ZONING PERMIT APPLICATION

FULL NAME GEORGE DEBECIK TELE # 612-770-9210
 MAIL ADDRESS 10635 NORTHMARK Drive
 CITY Eden Prairie STATE MN ZIP 55344
 911 ADDRESS OF PROPERTY 29986 436th Place
 CITY Aitkin STATE MN ZIP 56431
 TOWNSHIP FARM ISLAND
 LEGAL DESCRIPTION LOT 9 - SHADY ACRES PLAT
 SECTION 28 TOWNSHIP 4.6 RANGE 27

Permit App 41811

This permit application was withdrawn. I'm attaching the email conversations and also some of the drawings. This is a small lot and is difficult to meet setbacks.

Proposed Garage Area Calculations

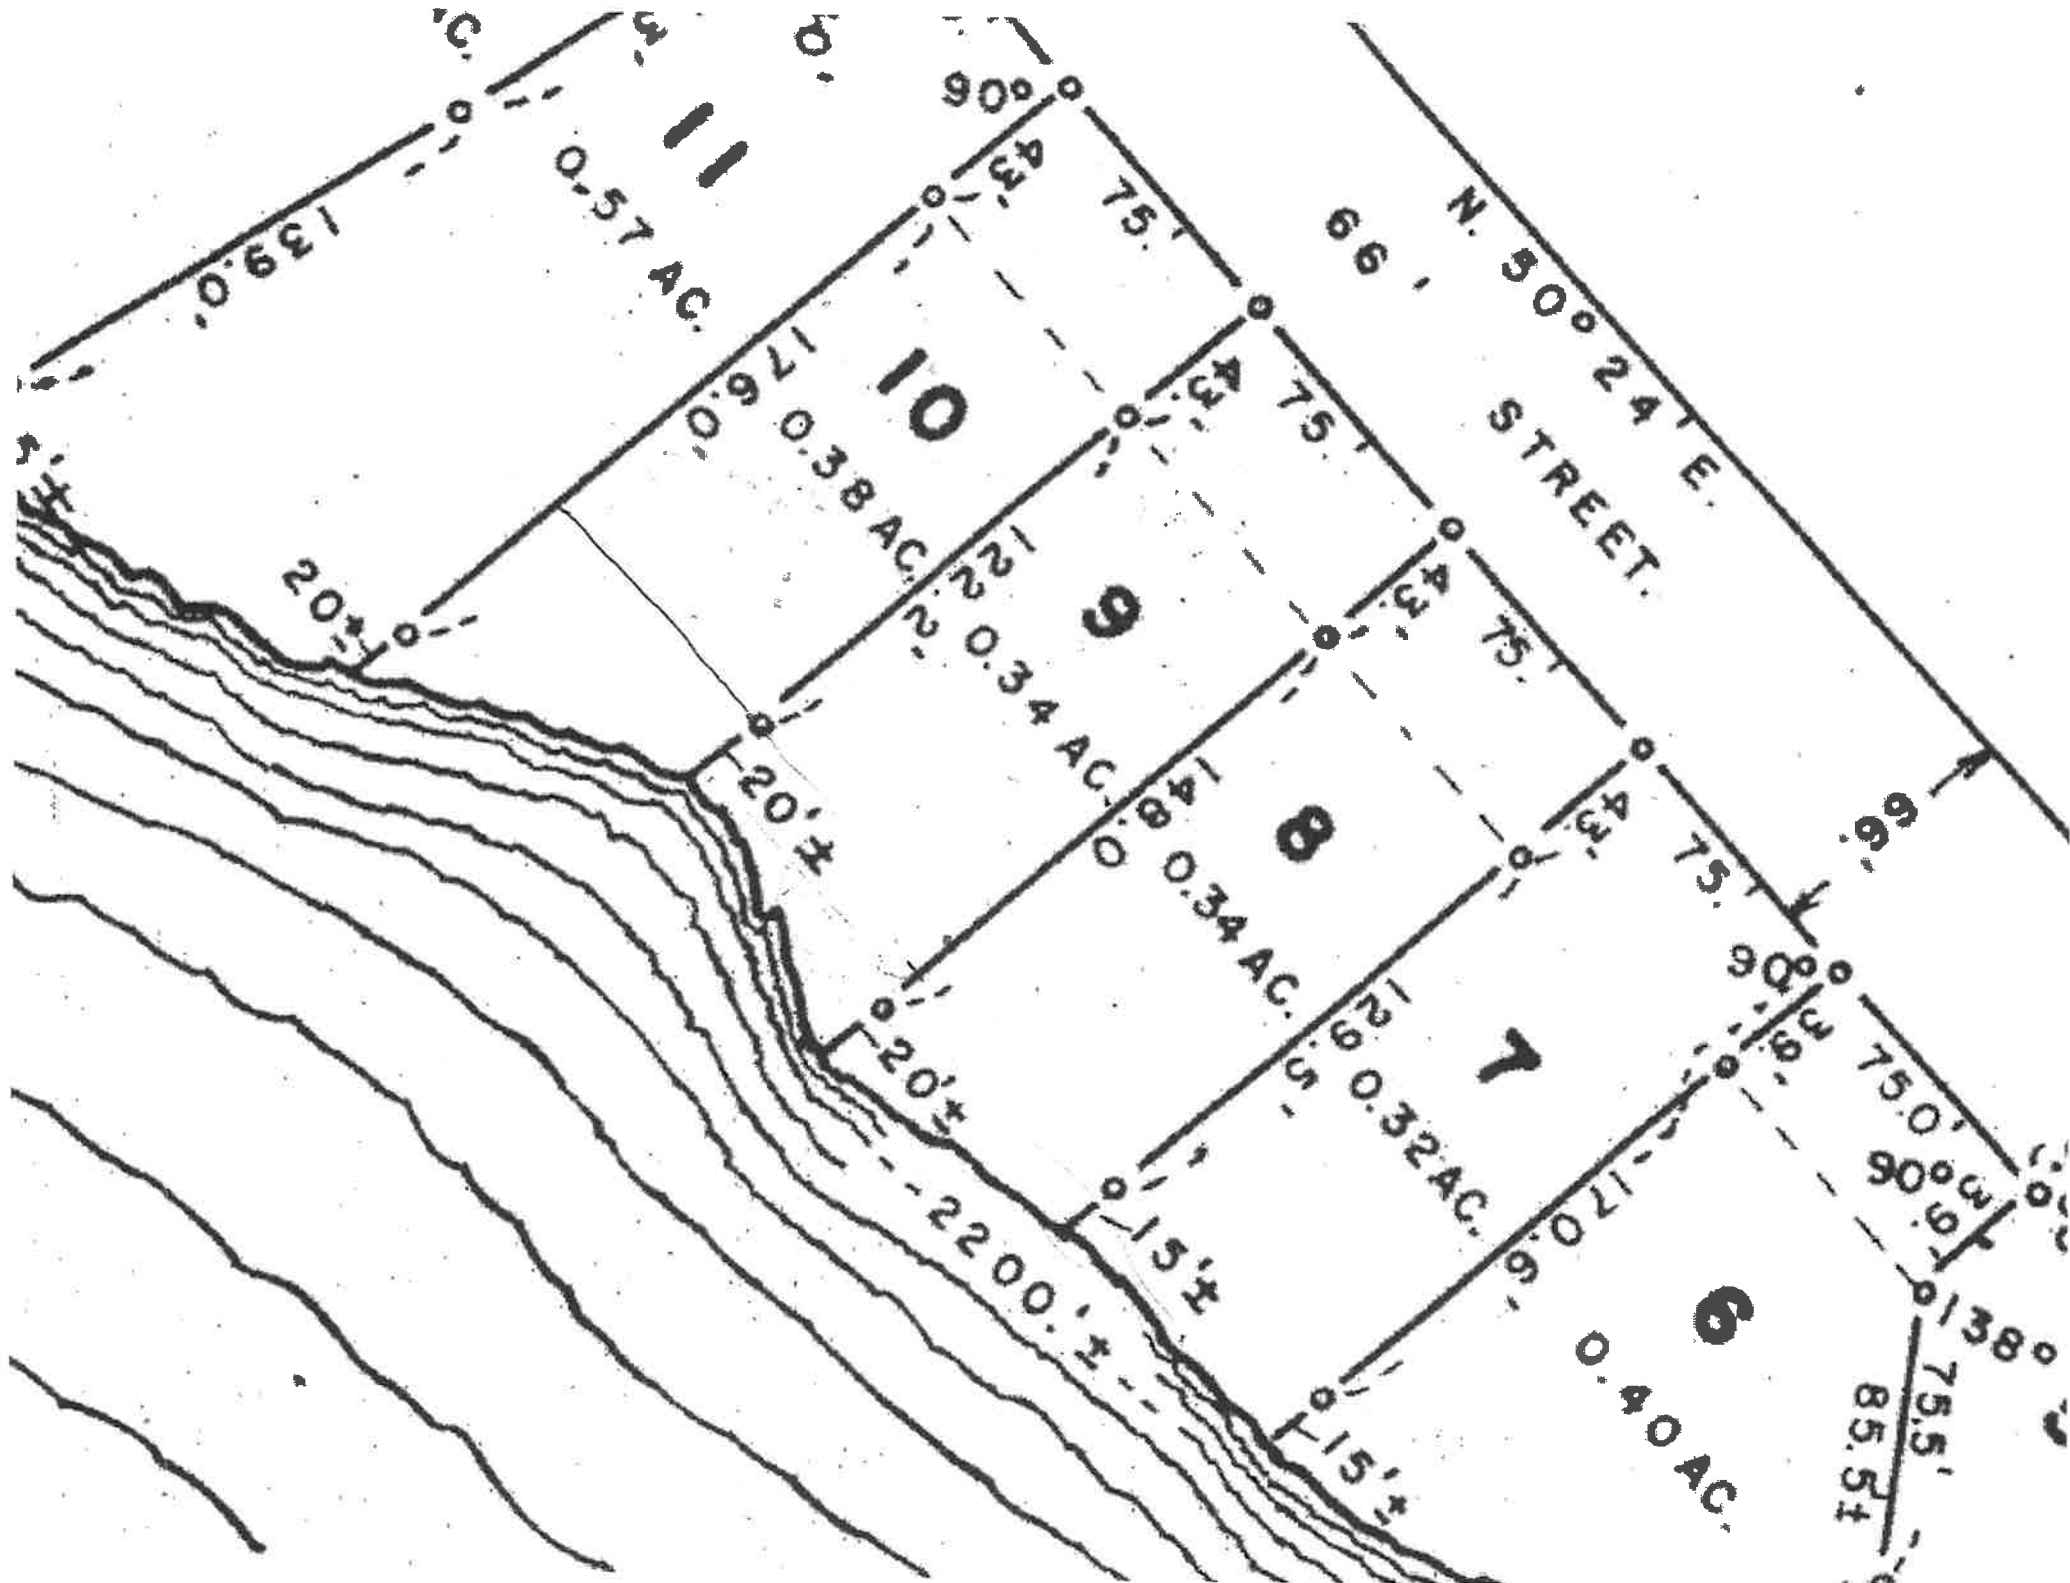
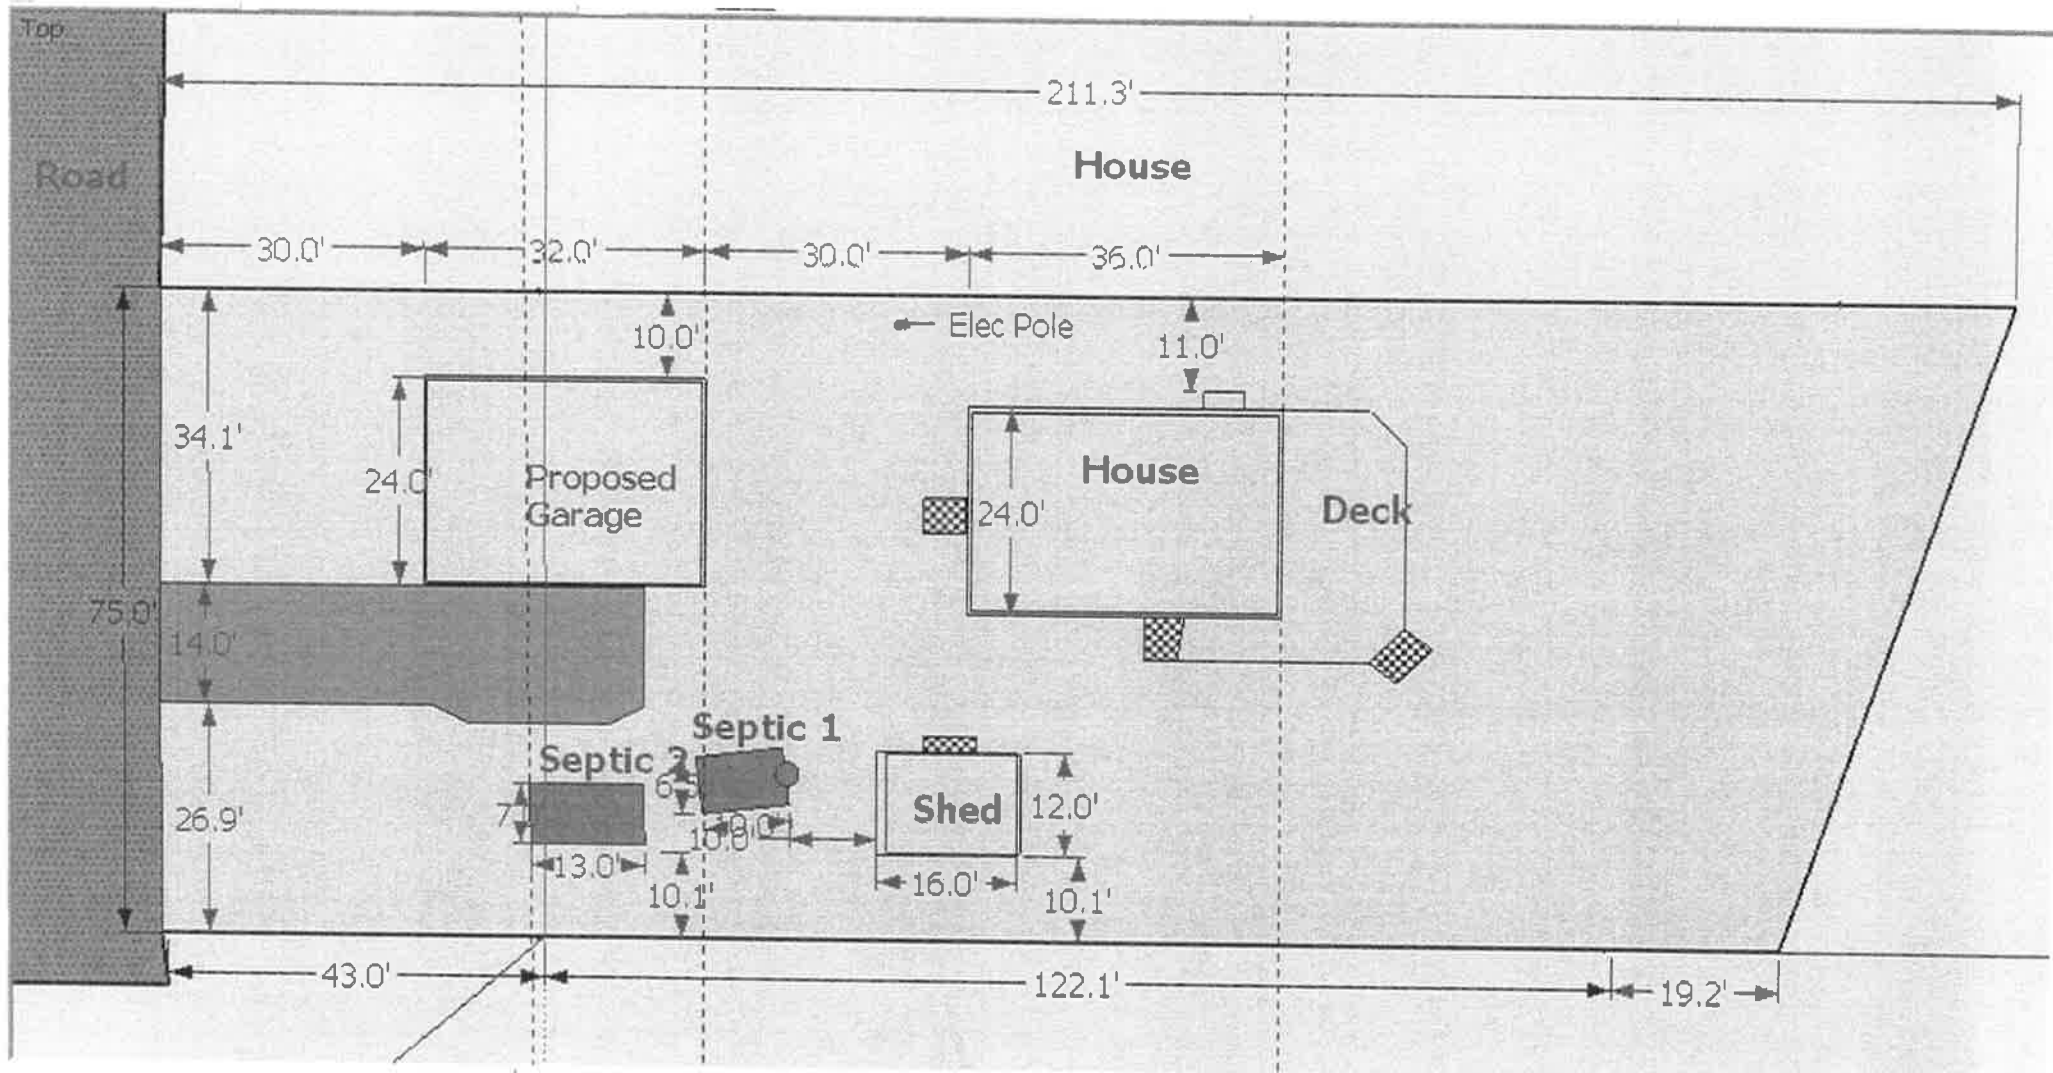
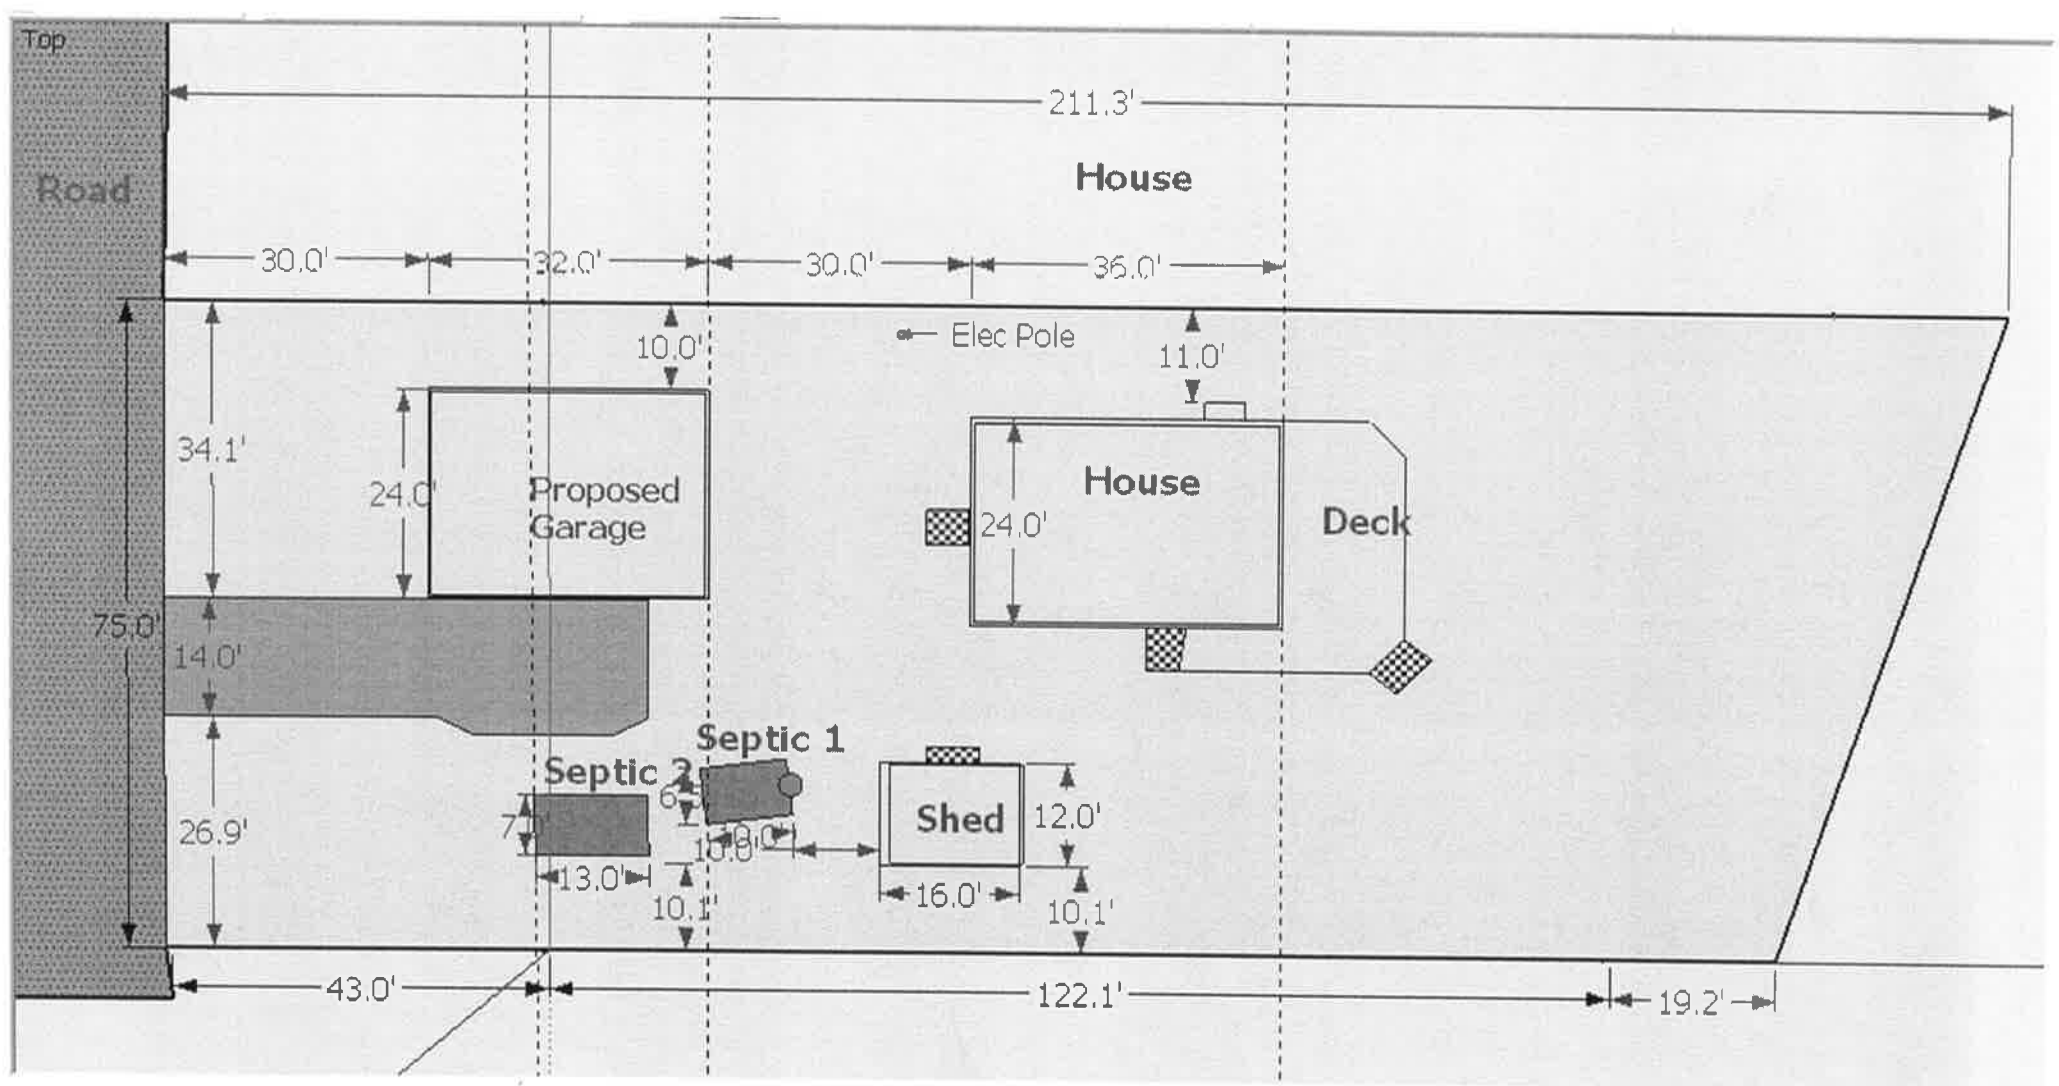
Attached are three pictures that describe our new plan. We are going to remove the existing 1000 gal septic tank and replace it with two 1500 gallon tanks. The 1500 gal tanks are 10' 8" long and 6'2" wide. I was told we could put them in any order and as close to each other as we wanted. This will significantly push back the shed so it will be behind the 100' set back line from the lake and still allow the shed to be over 10' from the tanks.

I have "moved" the garage so it is 11' from property line so the overhang will be 10' from line. I will remove 3' from the end of the side deck to get to the 15% value required.

Looks like that will work. I double checked and I won't need another site visit to confirm the shed setback. We will confirm it when we do the post-construction inspection. However, we need an updated design from Mike O'Keeffe. He could email that to me if he wants to and then I can issue the permit.
